ADDENDUM 1
LANDING, STAIR & SIDING REPAIRS
RICHLAND MIGRANT CENTER
479 BERNARD AVE.
YUBA CITY, CA 95991

BUILDING 'E'

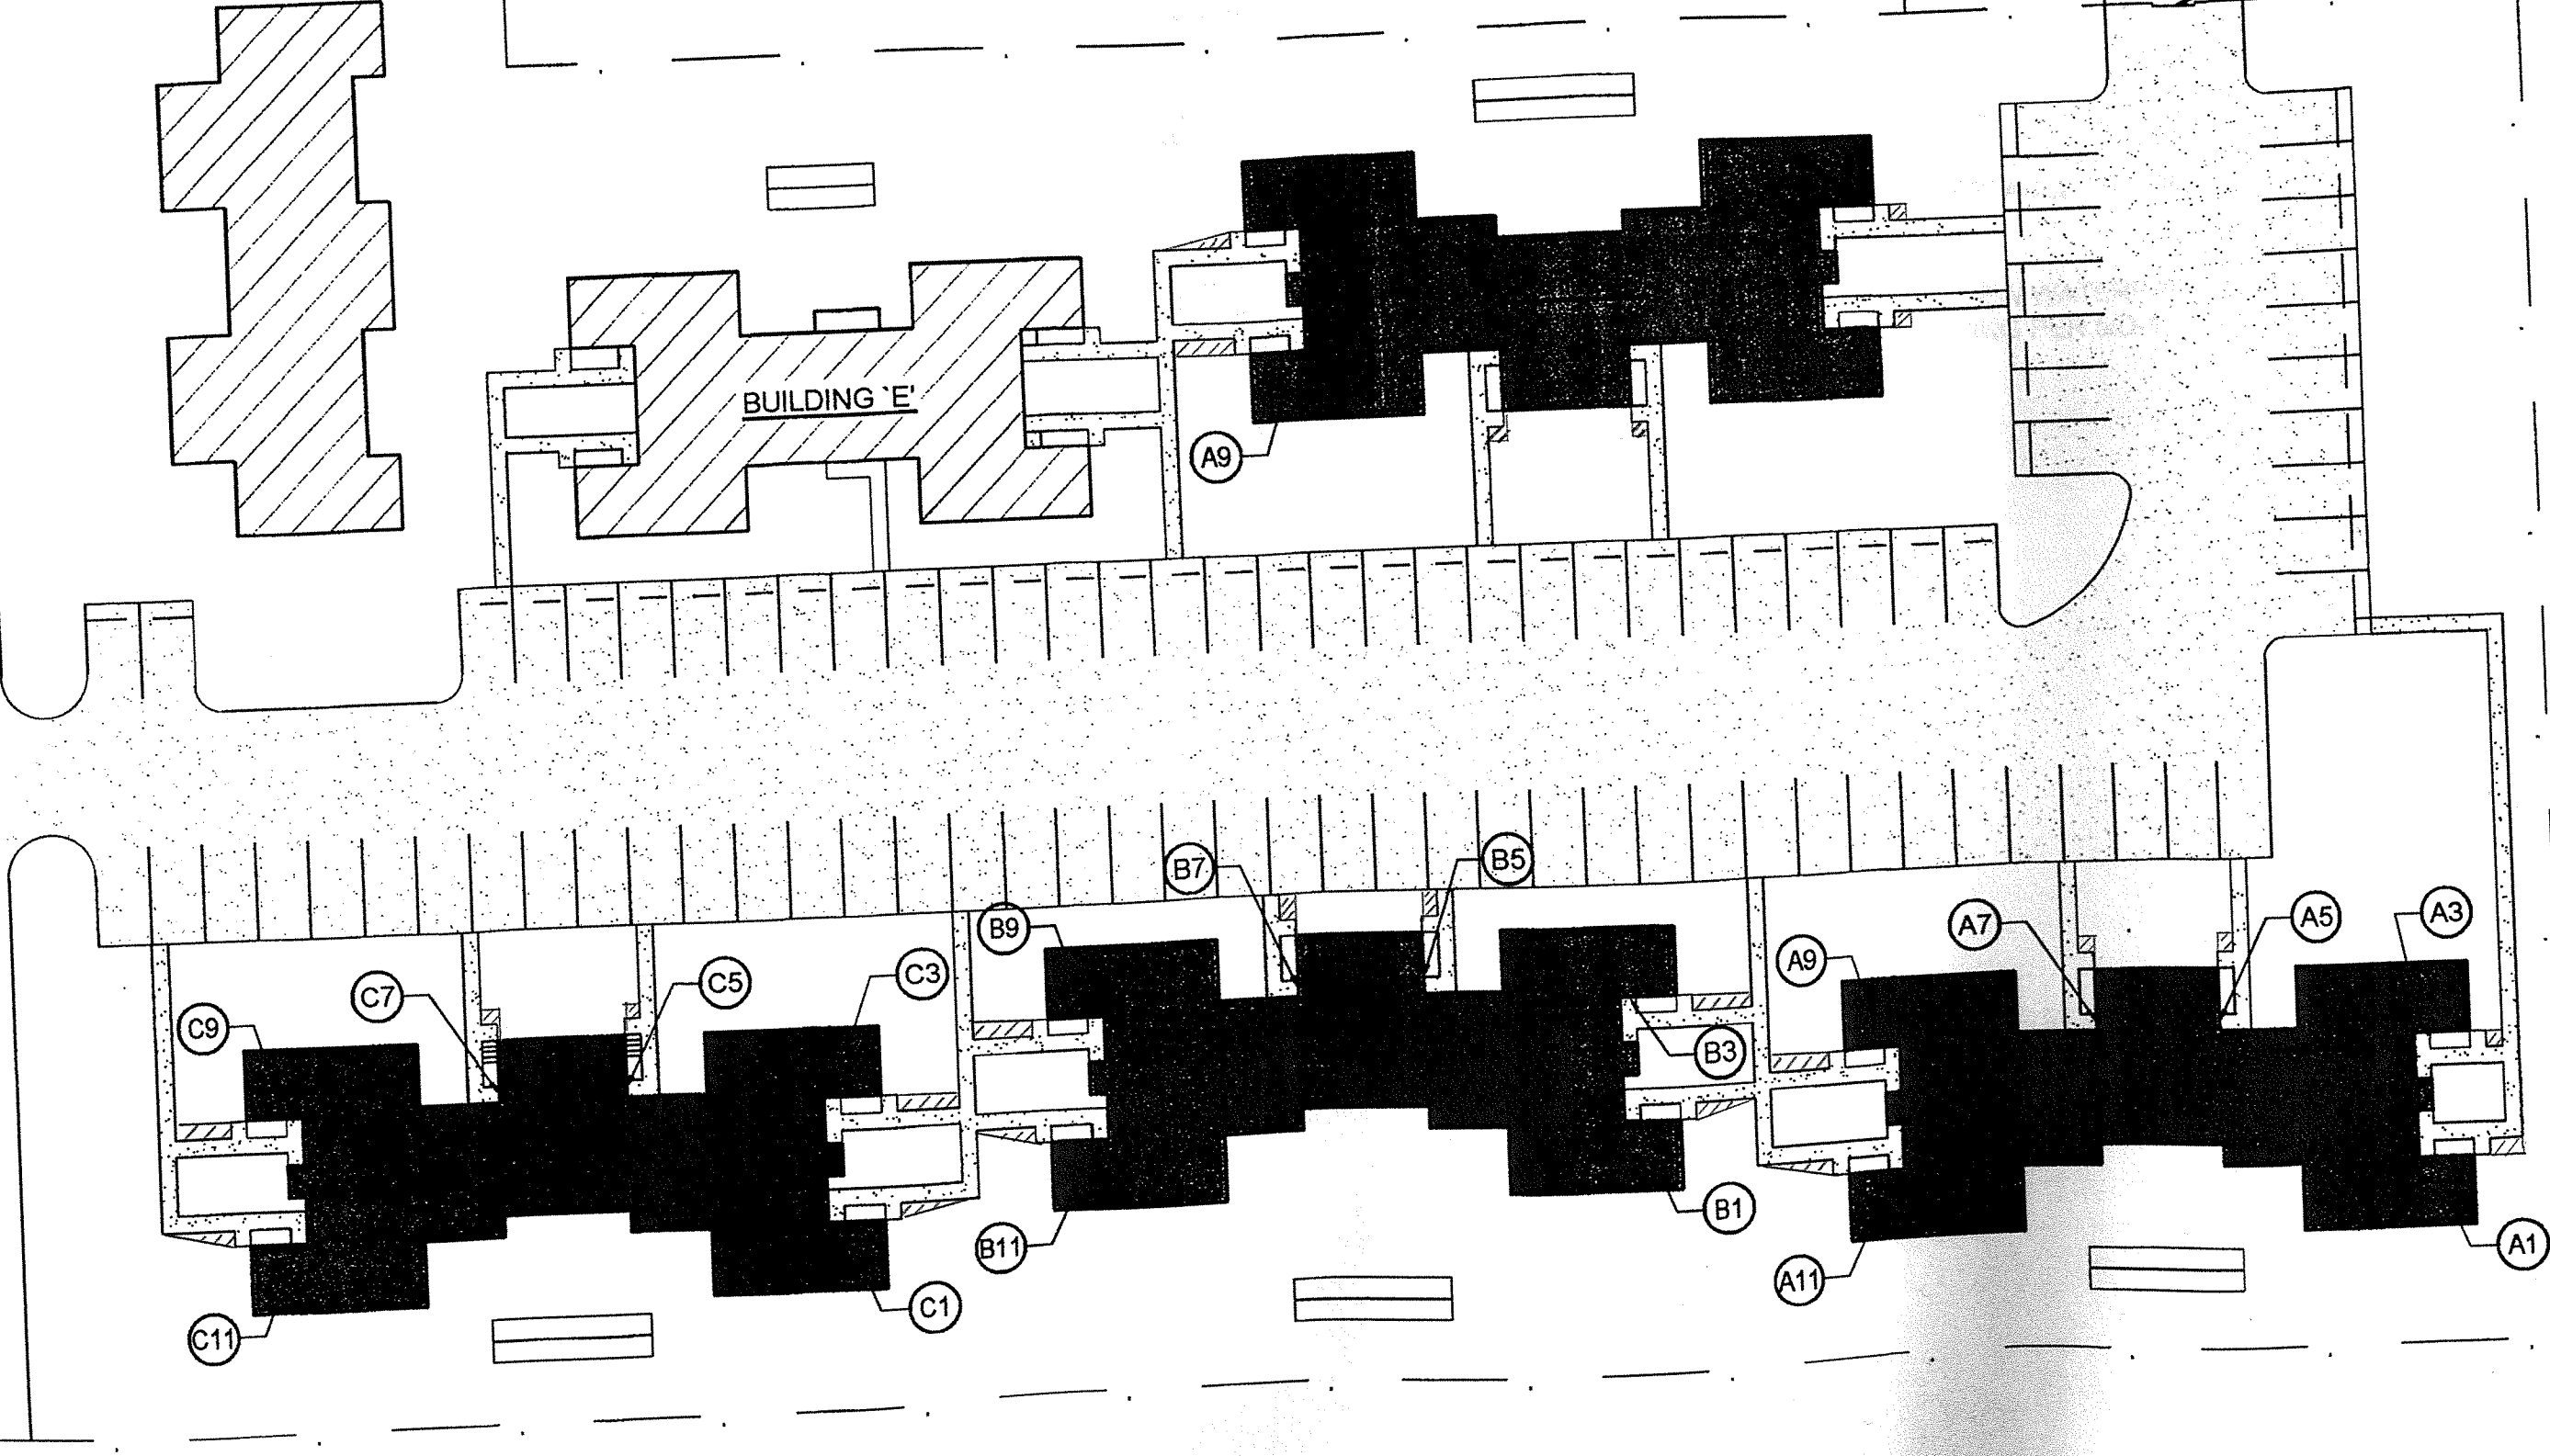
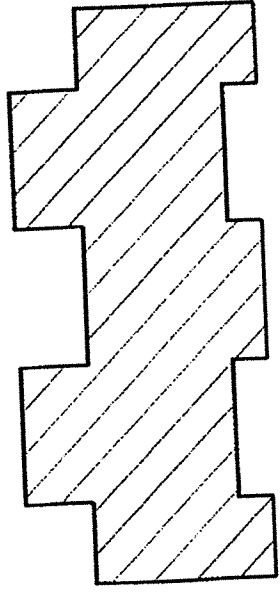
1. How much new concrete do we add to the existing landings at the front of the buildings?

Do to the extended railings at the bottom of the stairs the concrete sidewalks will need to be extended. Due to varying site conditions please see the drawing attached to this addendum for new concrete locations. The cross hatched areas are the locations of the new concrete.
